## V2500-A1 SERIES PROPULSION SYSTEMS SERVICE BULLETIN

This document transmits the Revision 1 to Service Bulletin V2500-NAC-71-0257.

NACELLE – AIR INLET COWL – INSTALLATION OF A5 TAI OUTER DUCT AND ACCESS PANEL ON A1  
AIR INLET COWLS

Replacement of TAI Access Panel and Outer Duct  
Figure 1, Sheet 1 of 3

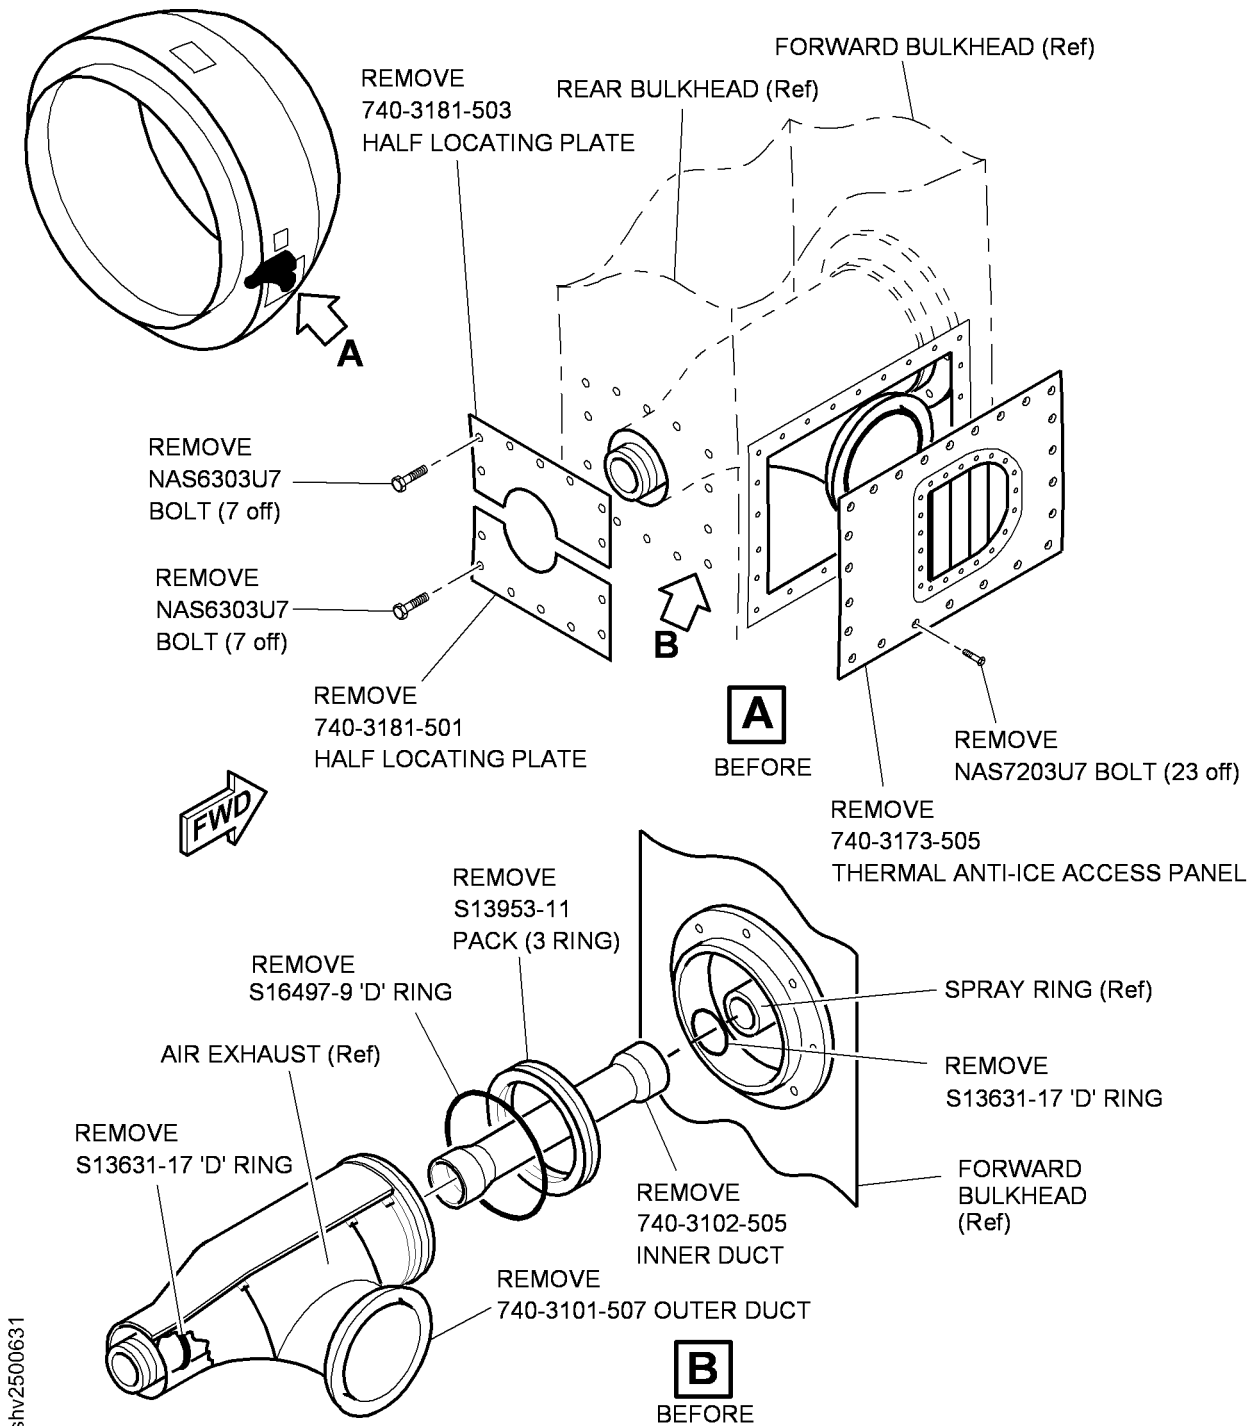
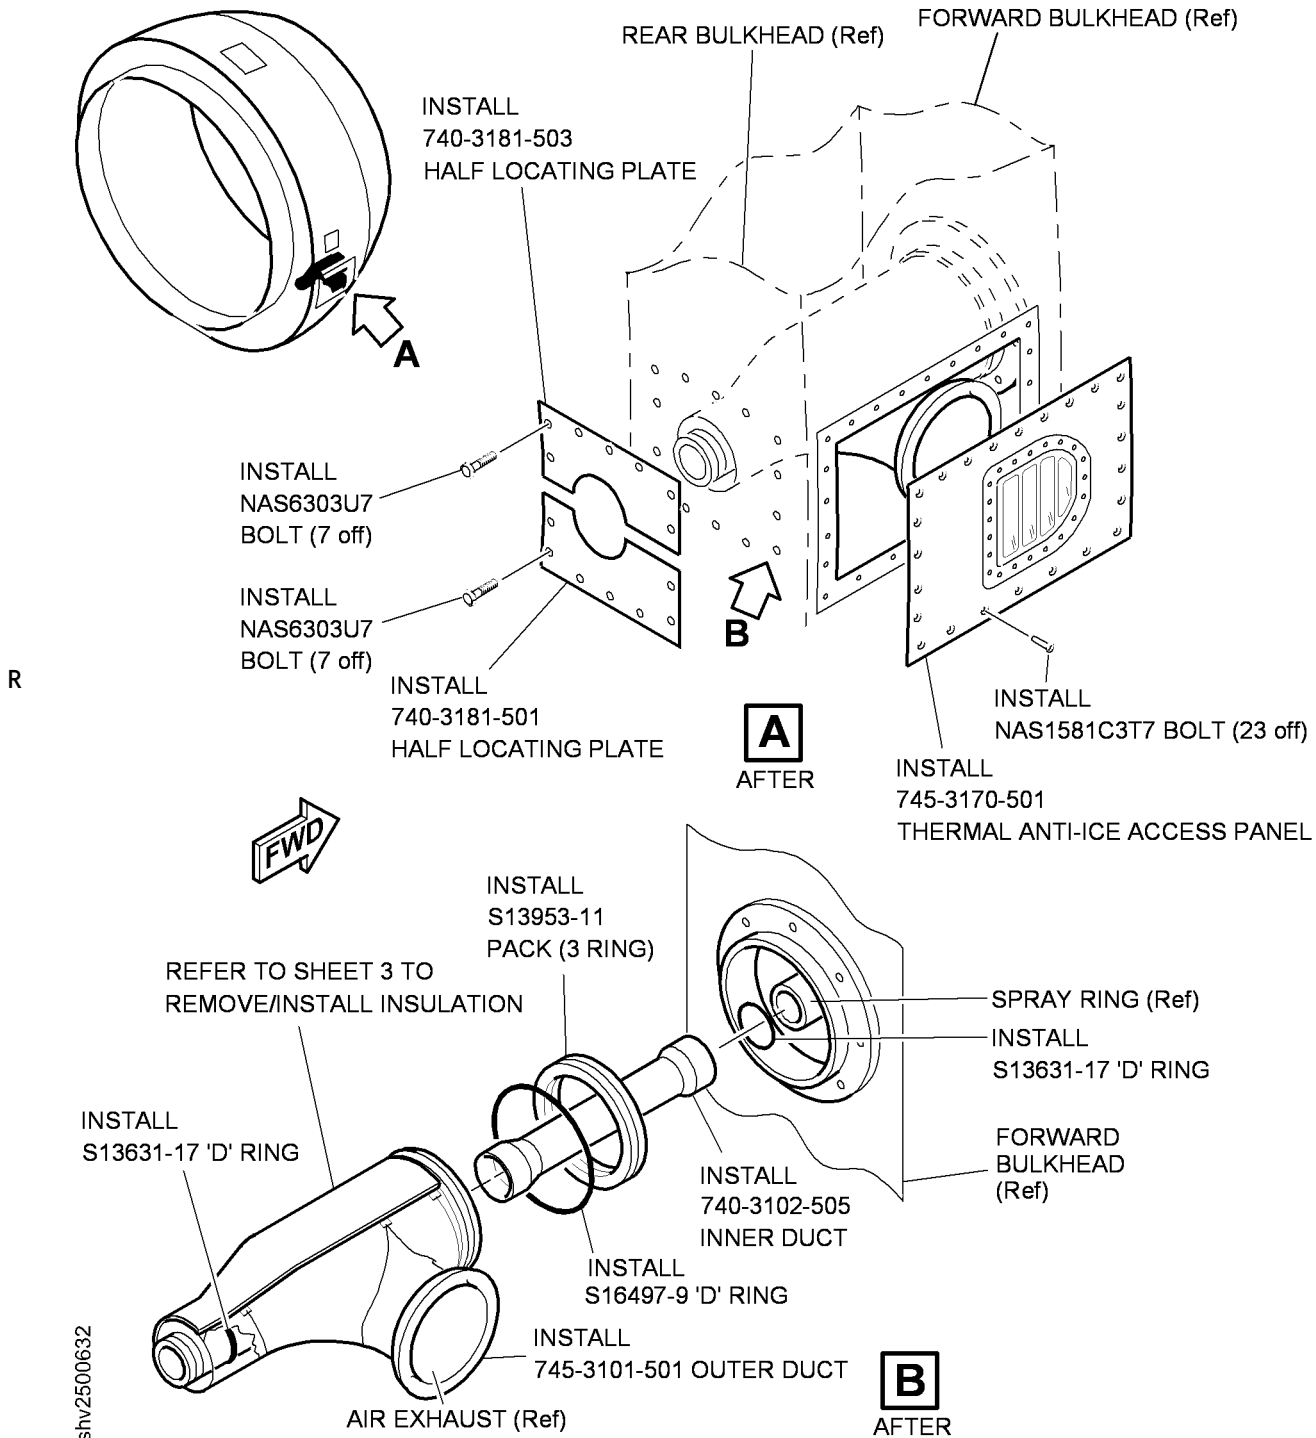
- (a) The TAI Access Panel is removed.
- (b) The TAI Inner/Outer Duct Assembly is removed from the Air Inlet Cowl and the Outer Duct is removed and replaced with a new Outer Duct.
- (c) The TAI Inner/Outer Duct Assembly is then installed to the Air Inlet Cowl.
- (d) A new TAI Access Panel is fitted.

- (1) Remove the 23 NAS7203U7 Bolts to release the 740-3173-505 TAI Access Panel. Remove the Access Panel. Refer to Figure 1.
- (2) Remove seven NAS6303U7 Bolts to release the 740-3181-503 Half Locating Plate. Remove the Half Locating Plate.
- (3) Remove seven NAS6303U7 Bolts from the 740-3181-501 Half Locating Plate. Remove the Half Locating Plate.
- (4) Put your hand into the Air Inlet Cowl Aperture and hold the 740-3102-505 Inner Duct. Pull the Inner/Outer Duct Assembly away from the Spray Ring and remove from the Air Inlet Cowl. Discard the S13631-17 'D' Ring and put a Blanking Cap on the Spray Ring.

- (5) Cut the lockwire and remove the 1-07597-00-00 TAI Outer Duct Insulation from the Outer Duct.
- (6) Pull the 740-3102-505 Inner Duct away from the 740-3101-507 Outer Duct. Discard the S13631-17 'D' Ring, S16497-9 'D' Ring and S13953-11 3-Ring Pack.

- (7) Install a new S13631-17 'D' Ring to the aft end of the new 745-3101-501 Outer Duct as shown.
- (8) Install a new S16497-9 'D' Ring and a new S13953-11 3-Ring Pack to the forward end of the 745-3101-501 Outer Duct as shown.

- (9) Put the 740-3102-505 Inner Duct into the 745-3101-501 Outer Duct. Make sure the Inner Duct engages on the S13631-17 'D' Ring.
- (10) Secure the 1-07597-00-00 TAI Outer Duct Insulation on the 745-3101-501 Outer Duct with lockwire (CoMat 02-126), as shown.
